PRELIMINARY DRAINAGE REPORT

GRANDVIEW RESERVE FILING NO. 1

DATE:
May 09, 2022

PCD Filing No.: PUDSP2110

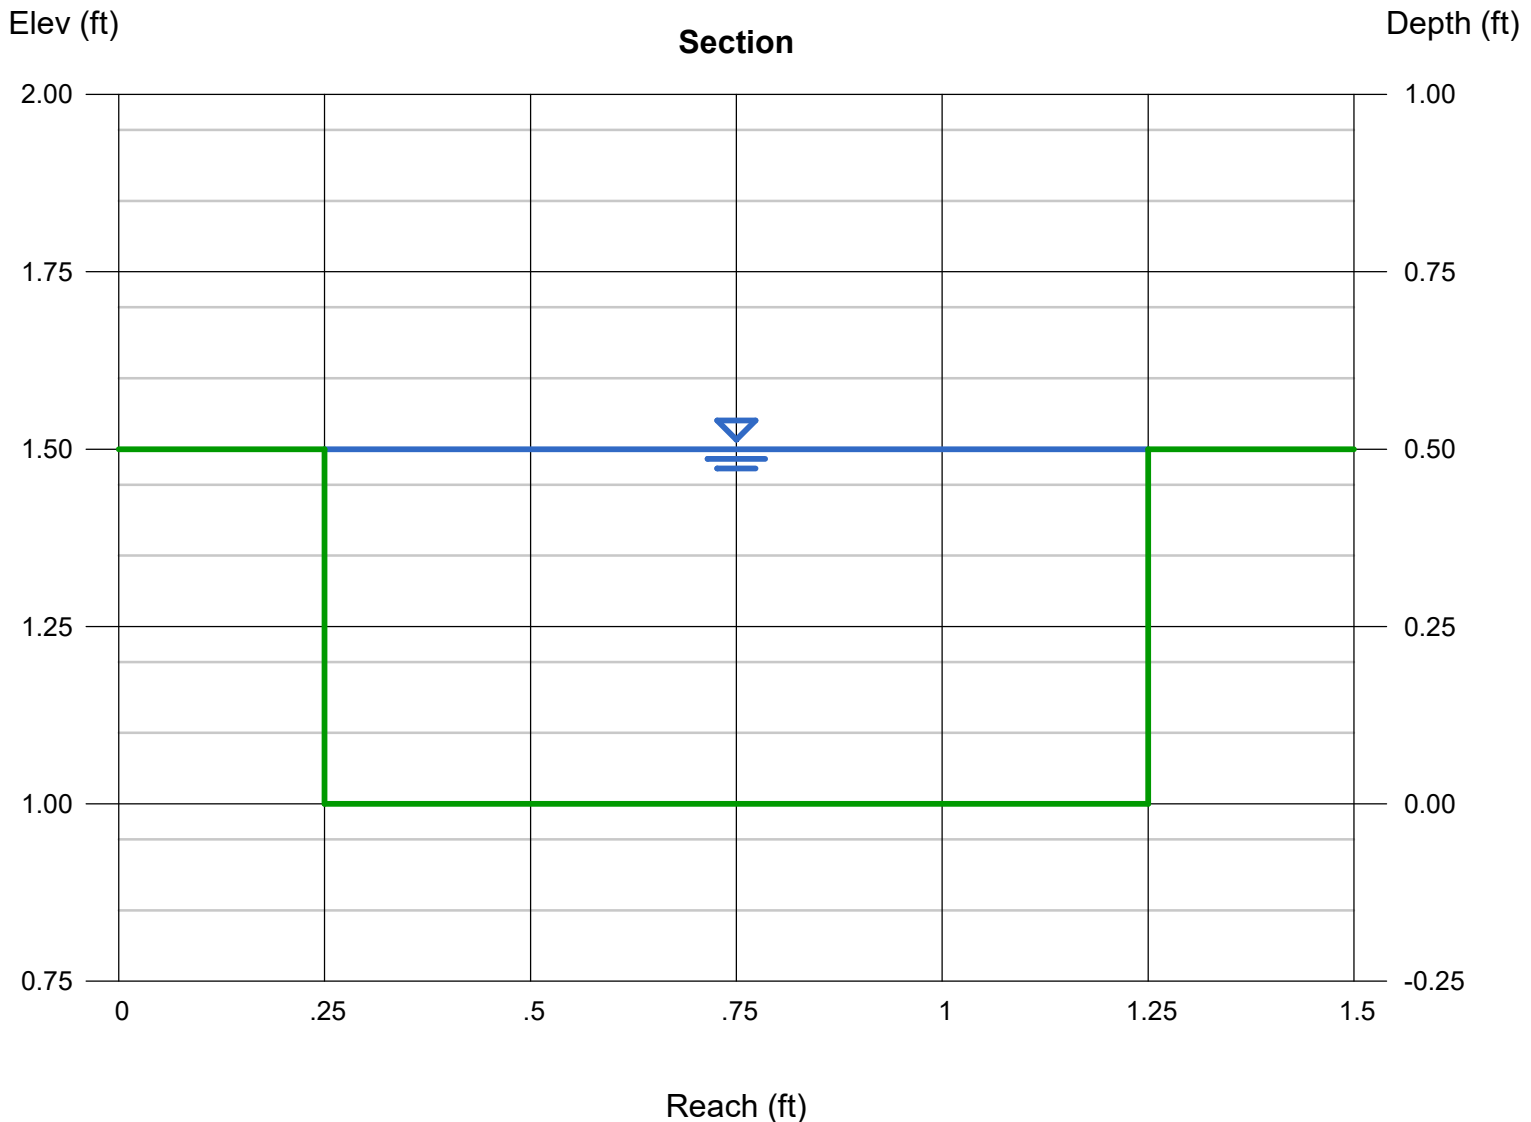
Label if this is for Sidewalk Chase not actual swale, which is next sheet
